**PROPOSED TE PŪTAHI LADIES MILE PLAN VARIATION  
RESPONSE OF MICHAEL LOWE ON BEHALF OF THE QUEENSTOWN LAKES  
DISTRICT COUNCIL**

**Response to questions raised by the Hearing Panel during the Hearing**

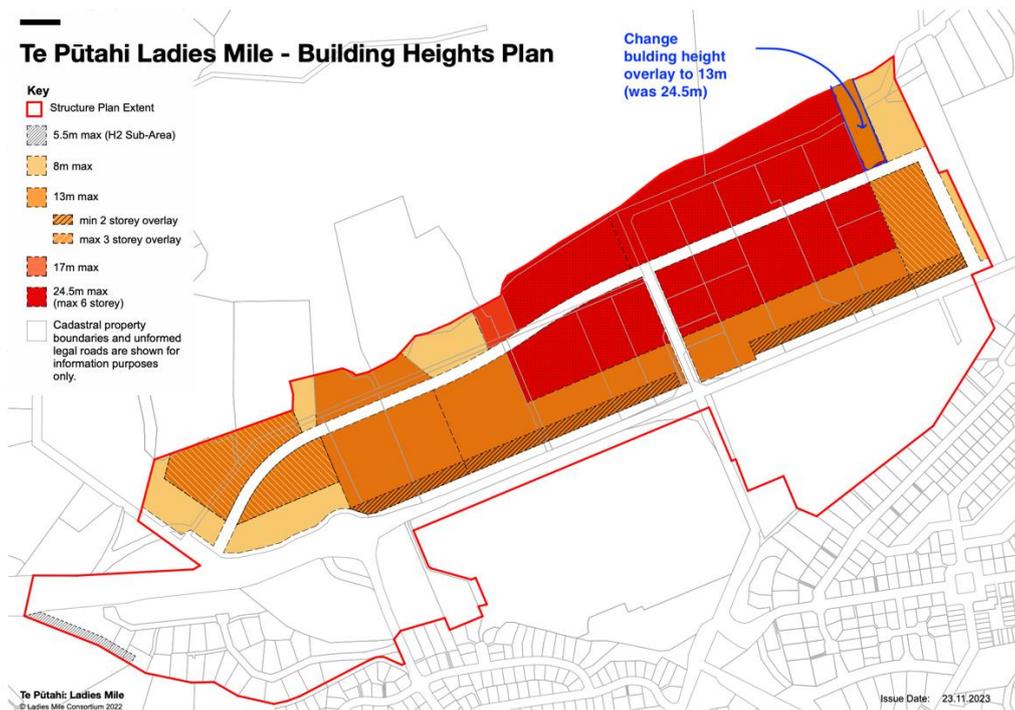
- (b) Building Heights Plan: Amend the Building Heights Plan to soften the transition between the HDR Precinct and LDR Precinct on the Eastern side of the Variation area as follows.

Presented by Mr Tim Allan Koko Ridge 08 Dec 2023

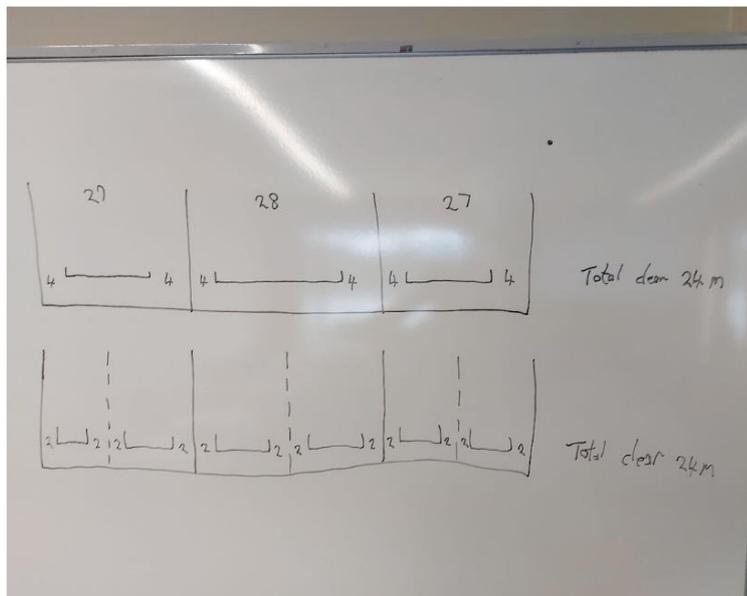
- (c) In opposition to my method above, Koko Ridge showed in the hearing that the existing subdivision consent lots would only be subdivided in half (as illustrated in the white board drawing below from Mr Tim Allan) and would result in an equivalent combined meterage of visual breaks in the built form along the elevation at the boundary as to what is enabled through the existing subdivision consent. While this is possible, it is not the only scenario that could occur as they have assumed that the existing subdivision boundaries are fixed and only further subdivided in half. I see no reason why Koko Ridge could not obtain a new consent to reconfigure their lot boundaries to create narrower lots.

Landscaping

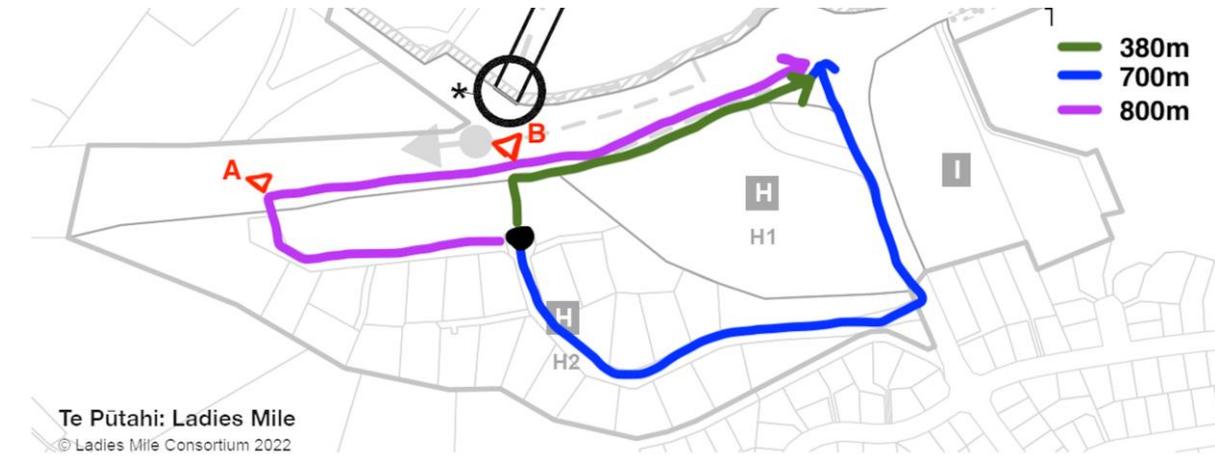
- (iv) Include a landscape buffer and more prescriptive fence/hedging requirement to screen the increased overlooking from yards. This would include adopting the provisions sought by Mr Giddens but with a few changes marked up in red below:

**Provide a minimum 3m deep landscape buffer** within the no build area **and** along the southern boundary of Sub Area H2 as shown on the Structure Plan. **Landscape planting** within the no build area shall:

- a) Be **50 percent** established prior to making an application for building consent.
- b) Comprise of the type of species detailed in Part 3 of Appendix 1 of the Shotover Country Special Zone.
- c) When mature achieve a visual vegetative screen extending the length of the no build area **and be at least 2m high**.
- d) Be maintained by the site owner.
- e) No buildings shall be located in the no build area.
